P 516942
A 516942
REPAIR

**ON-SITE SEWAGE DISPOSAL SYSTEM
HOWARD COUNTY HEALTH DEPARTMENT
BUREAU OF ENVIRONMENTAL HEALTH**

ADDRESS: 5425 Trotter Road PROPERTY OWNER: Sekira

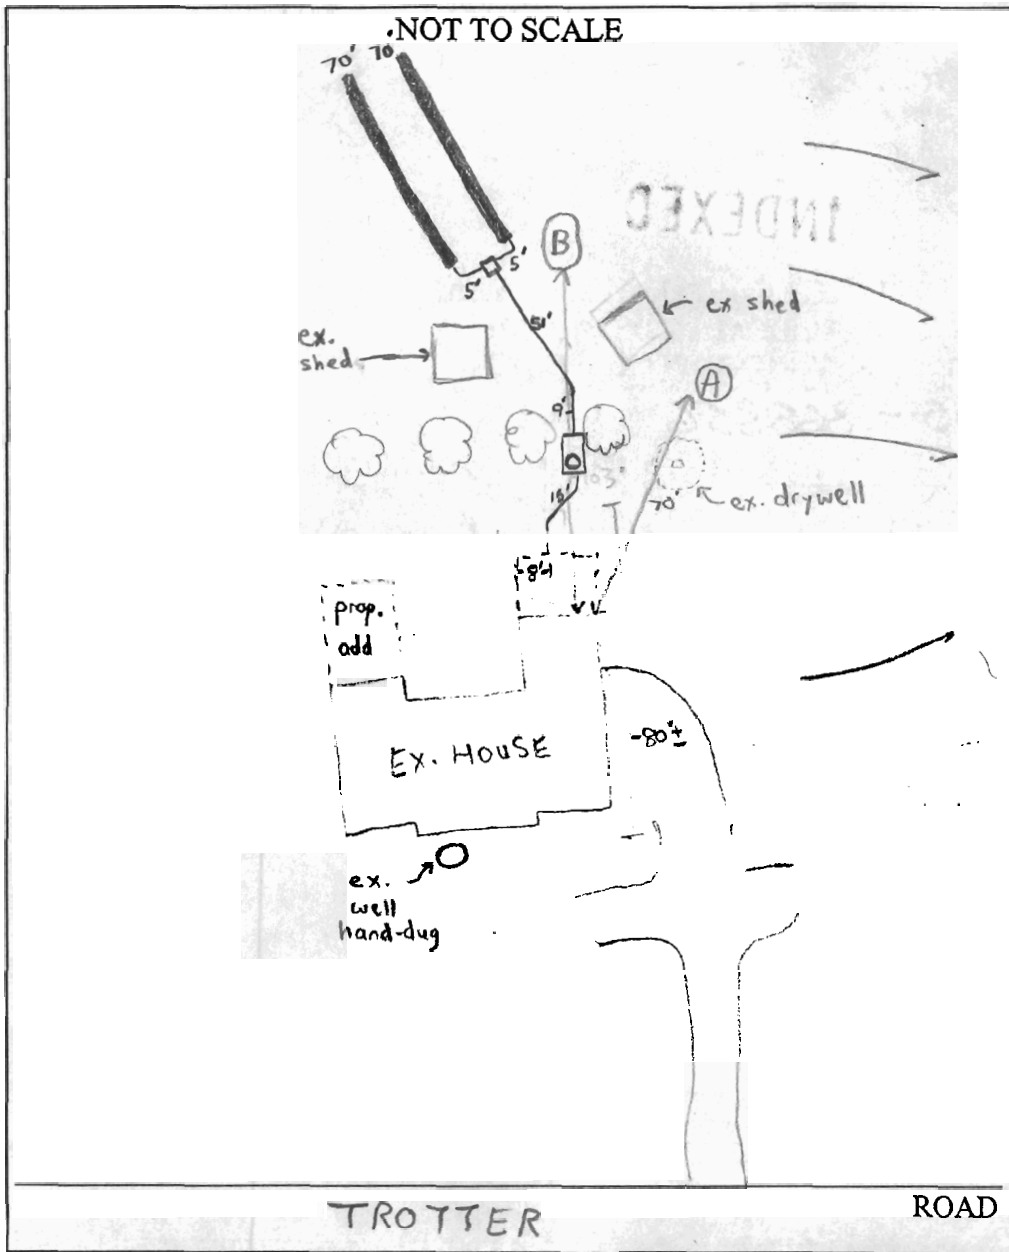
PRE-CONSTRUCTION 5/17/02 - EX. TANK TO BE REPL. W/ 1000 GALLON TOP SEAM & MOVED TO BE 10' FROM NEW ADDITION, 75-80' FROM EX. HAND DUG WELL, PERC HOLE DUG IN LOCATION (A) (HOLE ABANDONED DUE TO RESULTS), HOLE DUG IN LOCATION (B) SOILS MORE SUITABLE - INSTALL AS DISCUSSED - (SRV/JB)

5/17/02 - OK TO COVER ALL WORK, EXISTING S.T. COLLAPSED & FILLED, ALONG W/ EX. DRYWELL
